RE: SUB 2001-102 -- One-Step Final Plat of Allen Elementary School Addition

RE: SUB 2001-102 -- One-Step Final Plat of Allen Elementary School Addition

CASE NUMBER: SUB 2001-102 -- ALLEN ELEMENTARY SCHOOL ADDITION

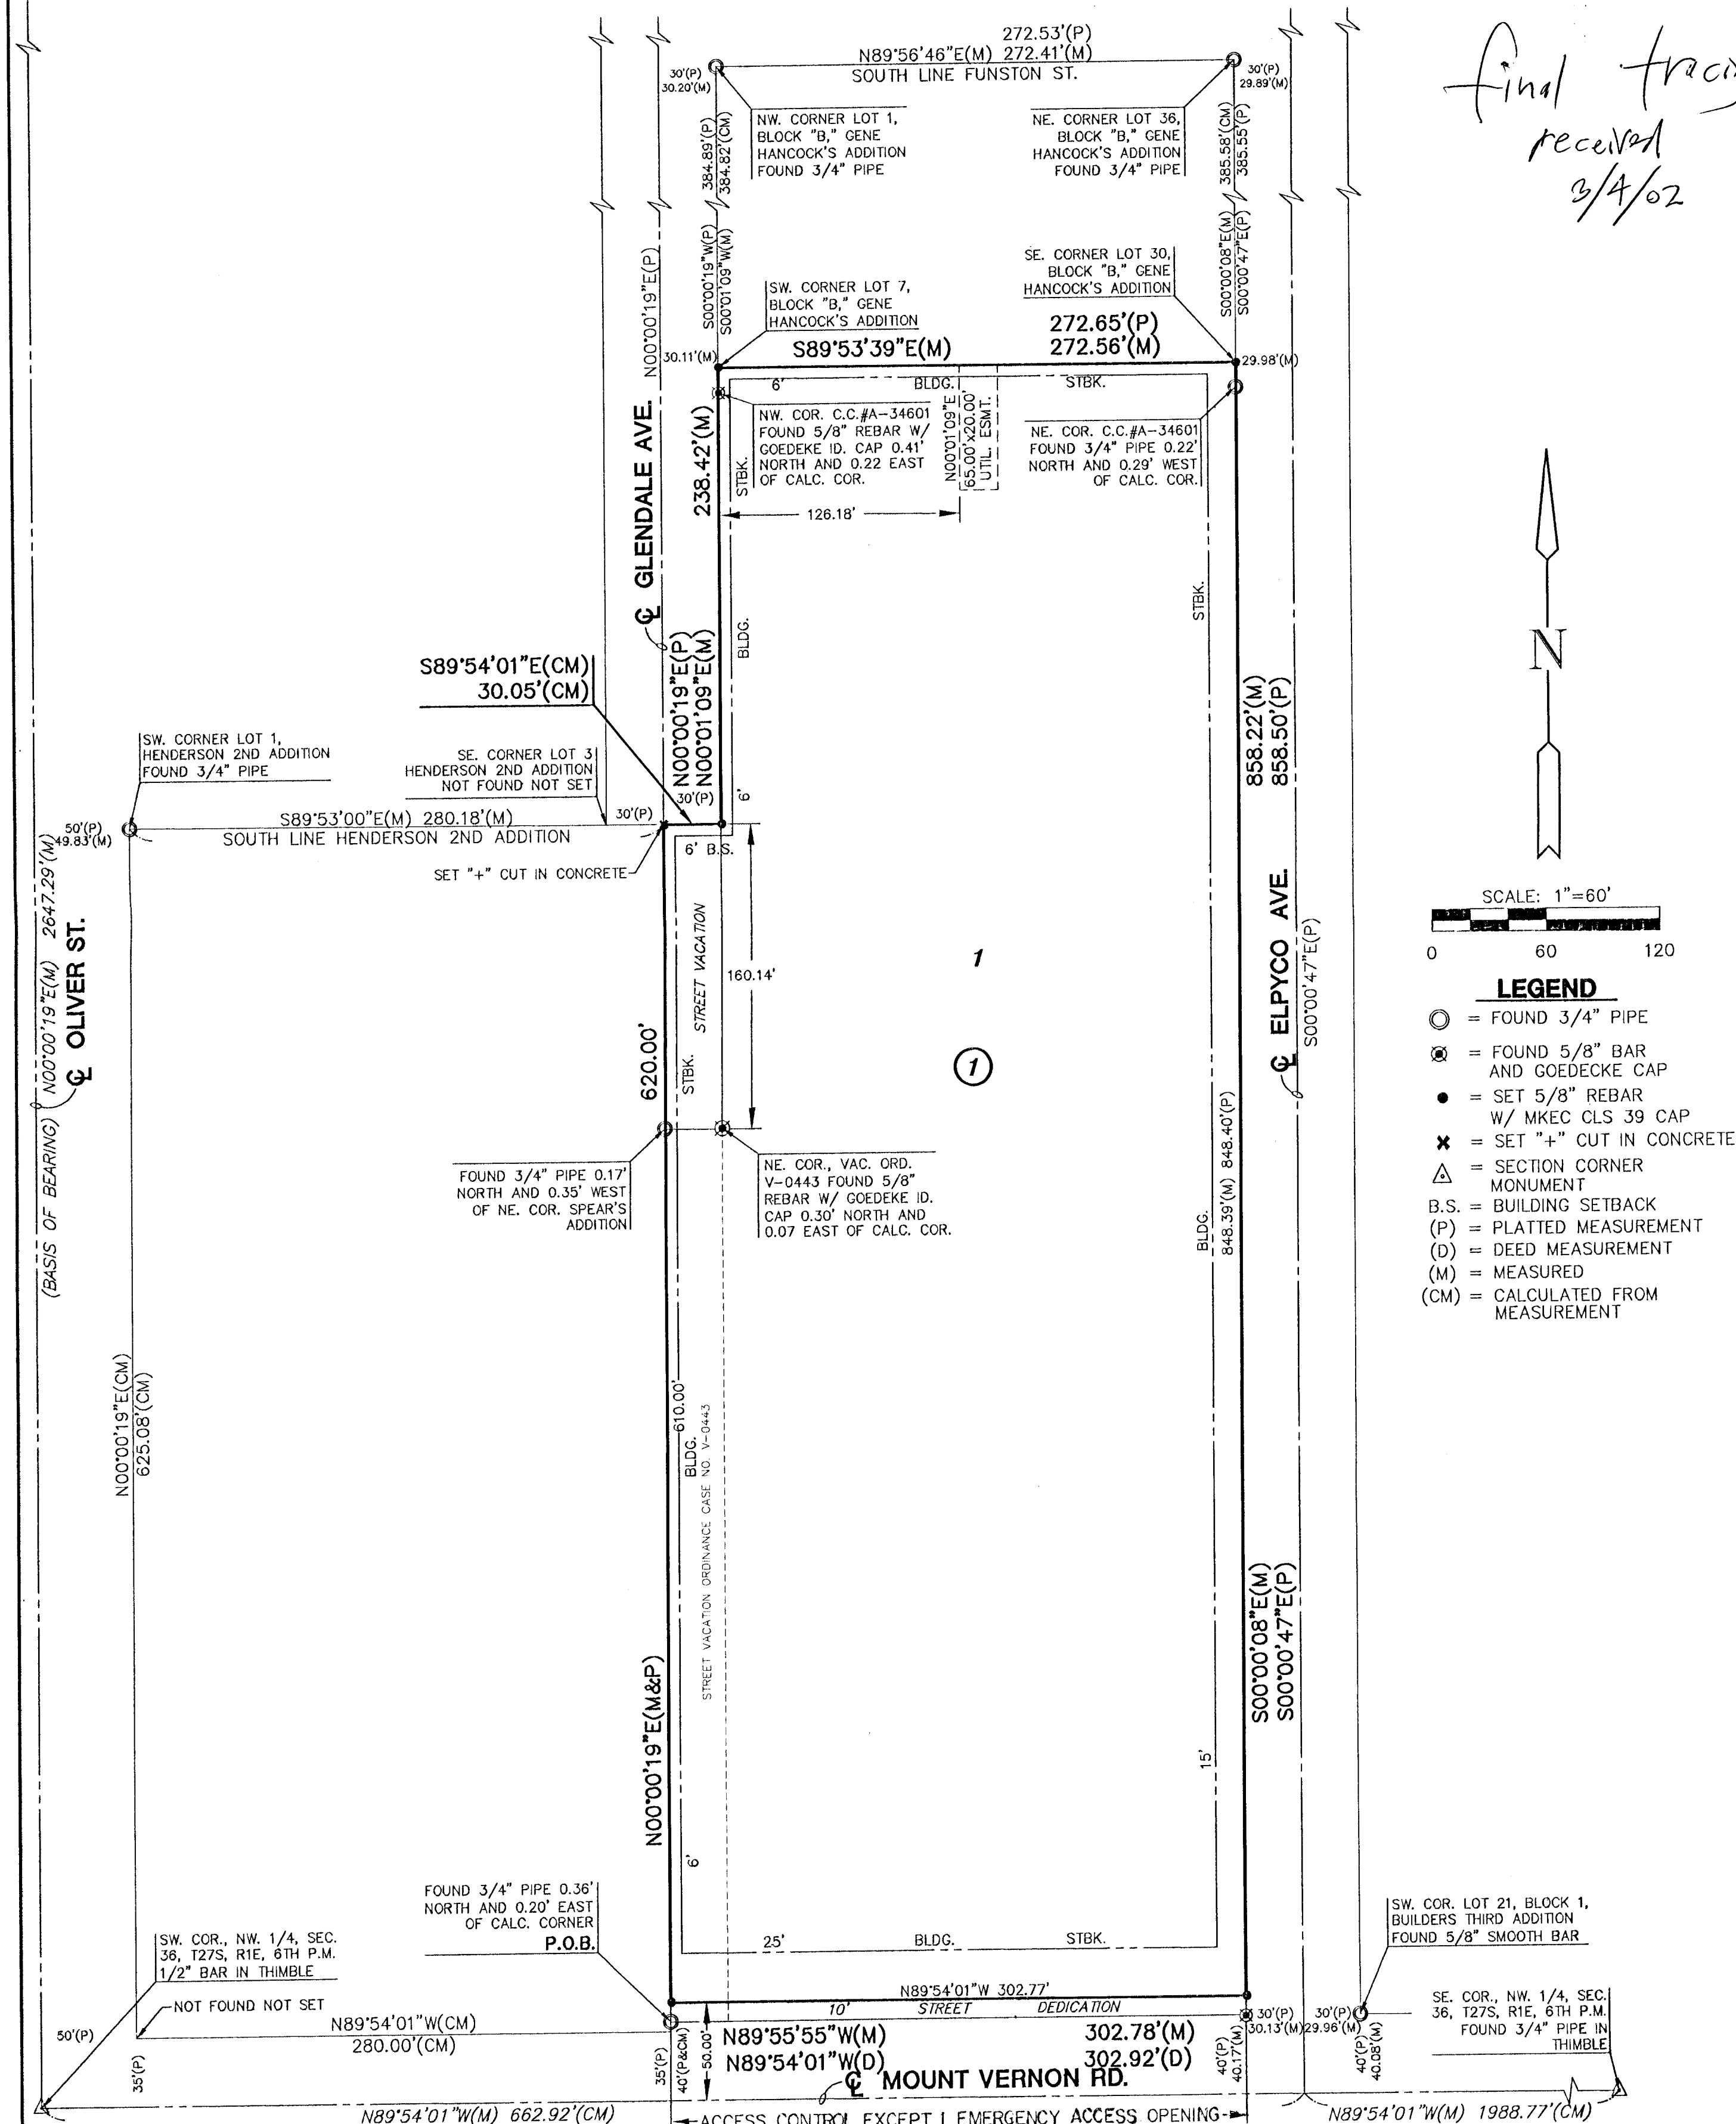
- A. Municipal services are available to serve the site. City Engineering needs to comment on the need for guarantees or easements. The north-south utility easement extending from the north property line needs to be reduced.

- C. City Engineering needs to comment on the status of the applicant's drainage plan. The drainage plan is approved.
- D. Traffic Engineering needs to comment on the need for additional right-of-way for Mt. Vernon which is designated as an arterial. The plat's text shall note the dedication of the streets to and for the use of the public. The applicant shall dedicate an additional 10 feet of right-of-way.

- E. Traffic Engineering needs to comment on the access controls. The plat proposes two access openings along Mt. Vernon and an emergency access. Traffic Engineering and MAPD have recommended complete access control along Mt Vernon Road, with the exception of an emergency access opening.

- F. A guarantee shall be submitted assuring the construction of an all-weather roadway surface for the emergency access easement. The text of the instrument shall indicate the type of driving surface to be installed and address installation and maintenance. Standard gating and signing are required per County Fire Department standards.

- J. If determined to be part of the Glendale right-of-way, the Applicant shall contact the adjoining property owner to the west regarding the proposed vacation of right-of-way for Glendale Avenue. A vacation case shall be approved before the approval of the plat. If no off-site right-of-way for Glendale exists, the portion of Glendale as depicted within the site may be vacated through the plat. The applicant shall dedicate additional right-of-way to obtain a 30-ft wide "L"-type turnaround for Glendale Avenue.

waived 12-19-01
per Paul
GUNZ.
